# STAFF RECOMMENDATION

NCPC File No. 6479

**PATENT OFFICE BUILDING  
SMITHSONIAN INSTITUTION  
F STREET STAIR RECONSTRUCTION, LANDSCAPE PLAN, SECURITY, AND SIGNS  
G, F, 7<sup>th</sup> and 9<sup>th</sup> Streets, NW  
Washington, D.C.**

Submitted by the Smithsonian Institution

Information and program signs installed on the sidewalk.

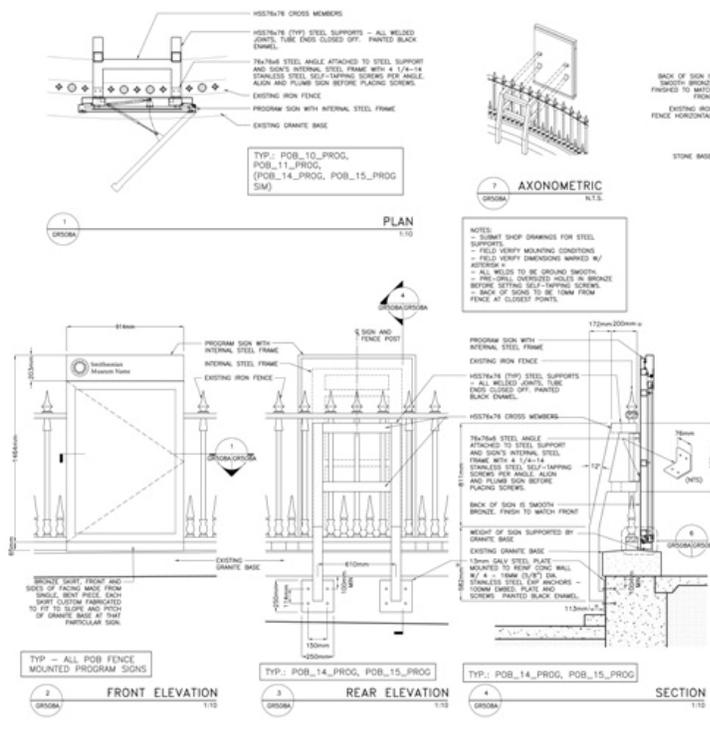
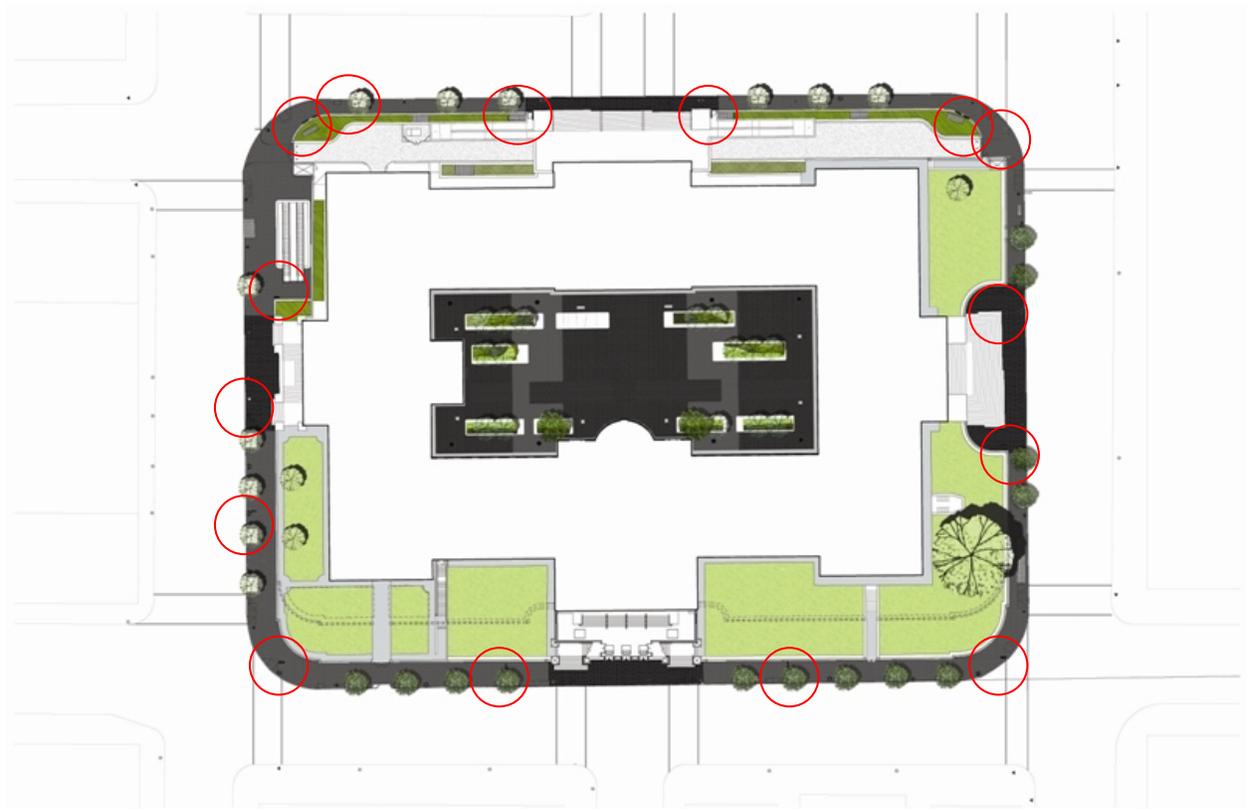
Regarding the fifteen information and program signs: the staff finds that the signs provide information about the museums, the current exhibits and programs, and wayfinding information. They help to animate the sidewalk around the reservation and provide color and interest. *Even given the size of the building and reservation, however, staff finds the number of signs proposed to be too many for the reservation and the building, especially given the future addition of street trees and light standards in the sidewalks.*

*The staff recommends that the Smithsonian consult with the Commission staff and the other review agencies, including the DC SHPO, to seek agreement on the most compatible and appropriate signage design for the building and the sidewalks around the reservation, and then submit it to the Commission for review and approval.*
